# CLAREMONT ARCHITECTURAL COMMISSION

3. ARCHITECTURAL AND SITE PLAN REVIEW #22-A01, PRELIMINARY REVIEW OF PHASE 2 OF SOUTH VILLAGE MIXED-USE DEVELOPMENT PROJECT - APPLICANT VILLAGE PARTNERS VENTURES, LLC - (FUNDING SOURCE: PRIVATELY FUNDED BY APPLICANT)

**ARCHITECTURAL AND SITE PLAN REVIEW #22-A01, PRELIMINARY REVIEW OF PHASE 2 OF SOUTH VILLAGE MIXED-USE DEVELOPMENT PROJECT - APPLICANT VILLAGE PARTNERS VENTURES, LLC - (FUNDING SOURCE: PRIVATELY FUNDED BY APPLICANT)**

# New Santa Fe Street

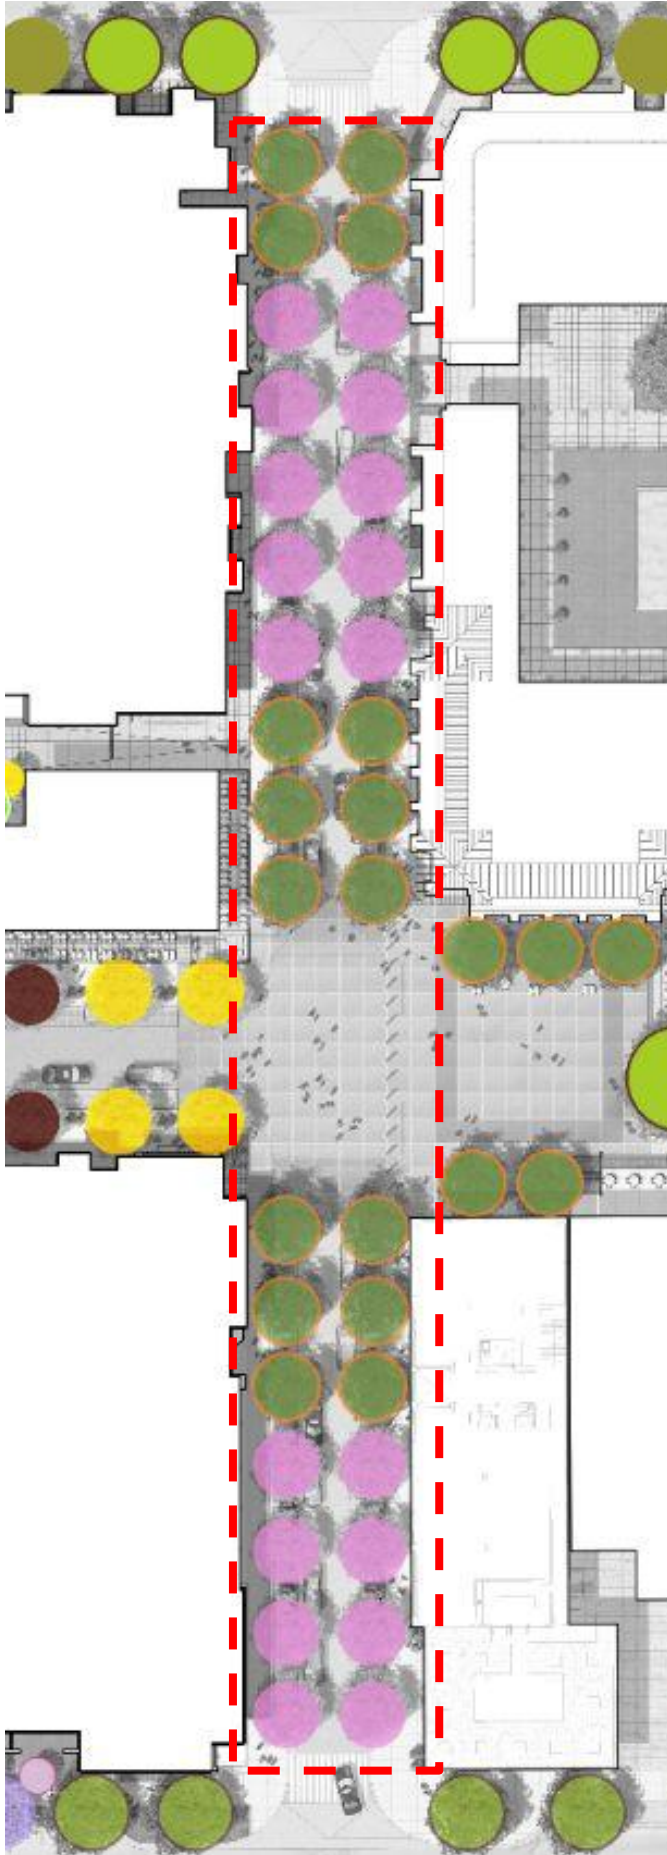
1. Staff suggests using slightly more ground-level plantings to help the project feel more like the Claremont Village.
2. Is the use of a single Sycamore as the focal point of the main event plaza appropriate? Another tree variety with a more substantial canopy and predictable form might be a better choice. Staff instead suggests using Sycamores in the bulb-out planters at street intersections. Here the additional soil volume and open space can allow these trees to achieve their mature height and size and contribute to the iconic tree canopy already found in the Claremont Village.
3. The Phase 1 paseo and entry plaza adjacent to the elevator lobby of the A block building seem to be lacking tree cover. Staff suggests small variety, deciduous trees be
